LSDP – EIGHT CENTRE DEVELOPMENT STAFF SUMMARY REPORT

LOCATION:	2416, 2418, 2420 S. 8 th Street
LAND OWNER:	Honey Creek Land & Cattle LLC
DEVELOPER:	Dan Dykema
APPLICANT/ ENGINEER:	Dan Dykema / CEI
ZONING DISTRICT:	C-4 (Open Display Commercial)
PLANNED USE:	Office
DESCRIPTION:	3 buildings comprising 32,000sf on ±7.28 acres
WAIVERS:	Curb cuts, connectivity, streetscape improvements, 10' sidepath with 6' greenspace, street trees
FEES-IN-LIEU:	On-site detention (\$19,602)
REQUEST:	Large-Scale Development Project approval
AUTHORITY:	Article III of Chapter 14, Rogers Code of Ordinances

CITY VIEW PROJECT #PL201800730

SITE PLAN REV DATE 11/19/18 REV-2 SHEET NO. C3

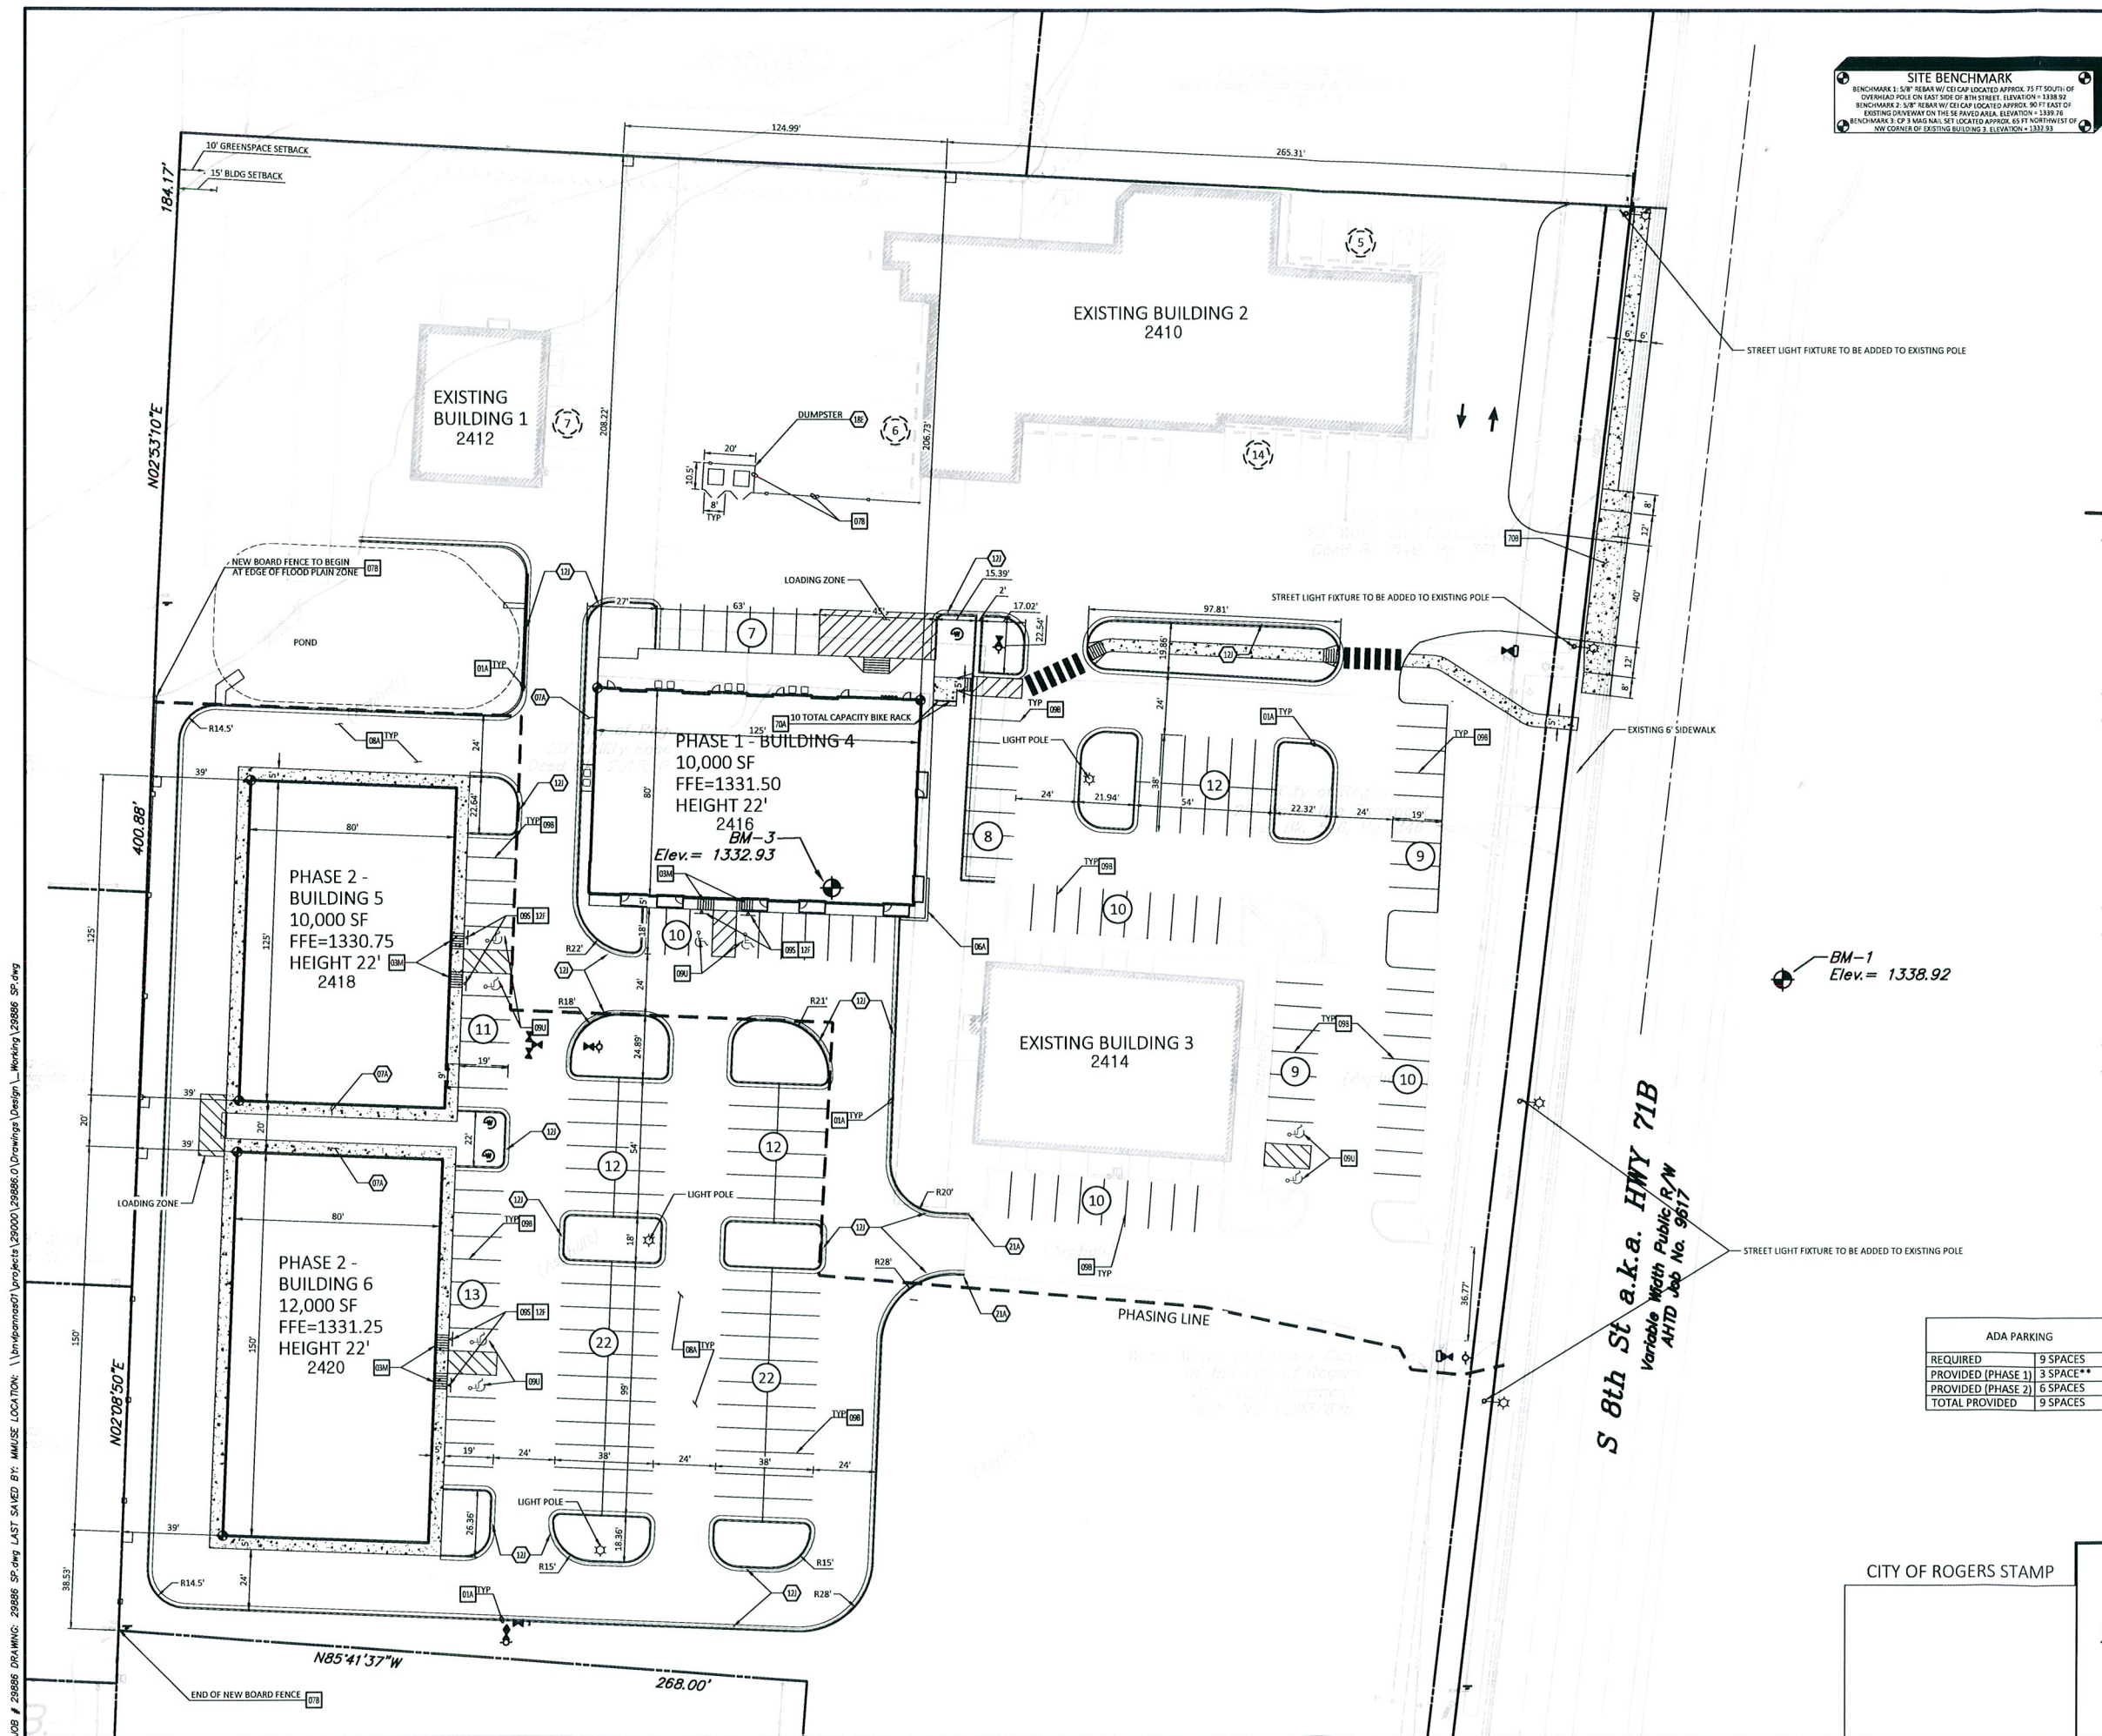
- 1) **Access Management:** The applicant requests a **WAIVER** to Sec. 14-260(1)e – Number of curb cuts permitted along S. 8th Street. See applicant's waiver request letter (tab 2).

- a) **Deny waivers to Sec. 14-260(1)(e) – Number of curb cuts permitted and to Sec. 14-260(1)f – Distance between curb cuts.** The site is permitted to have a maximum of 2 curb cuts based on the length of street frontage. Joint access is required that will allow access to all buildings on the site.

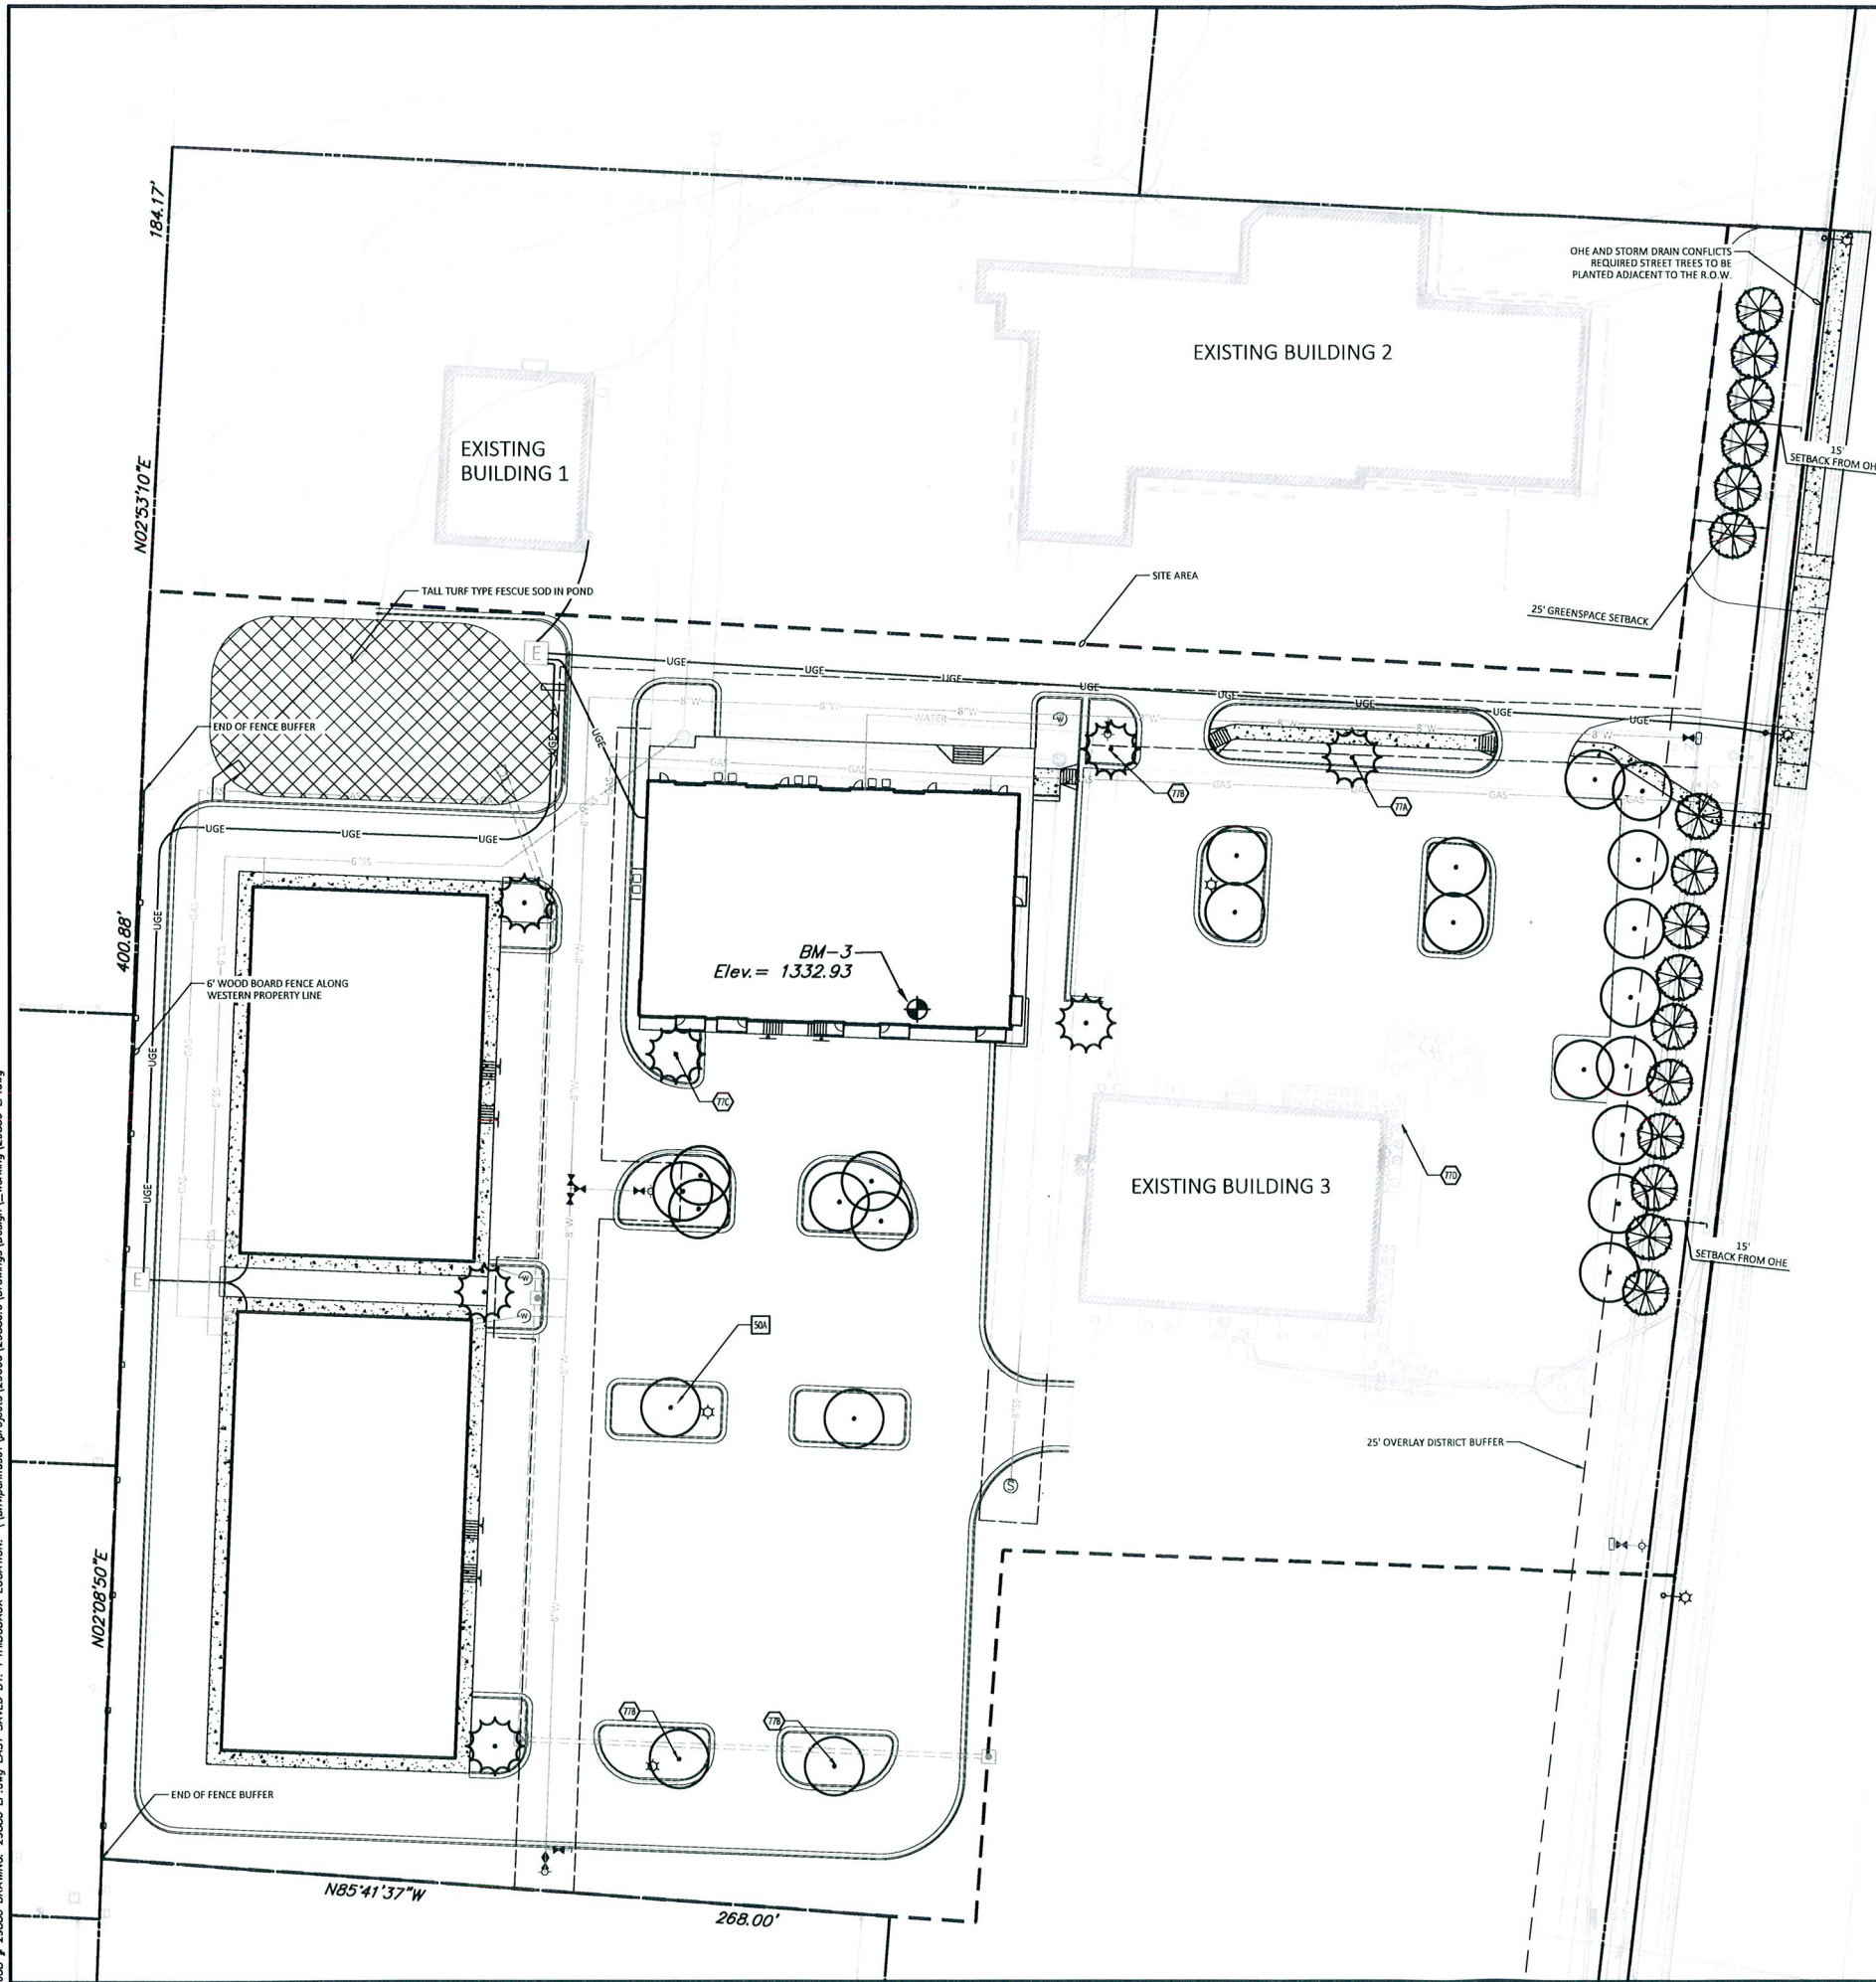
- e) **Deny waiver to Sec. 14-256(14)(g) for the requirement to provide street trees.** The greenspace between the back of curb and sidewalk appears to be within ArDOT right-of-way and not a Carroll Electric's private utility easement.

The proposed development is required to provide street trees within the street right of way in accordance with the master street plan section for Arterial street. The number and spacing of trees varies based on the size of trees proposed. However, based on the location of overhead power along the street and requirements for 15' offset from Carroll Electric, even the smallest trees cannot be planted in the right of way without violation of the required offset. Developer proposes to incorporate the required street trees within the development instead of in the street right of way. The number of required street trees will be provided in addition to interior plantings. See Landscape Plan for clarification of this request.
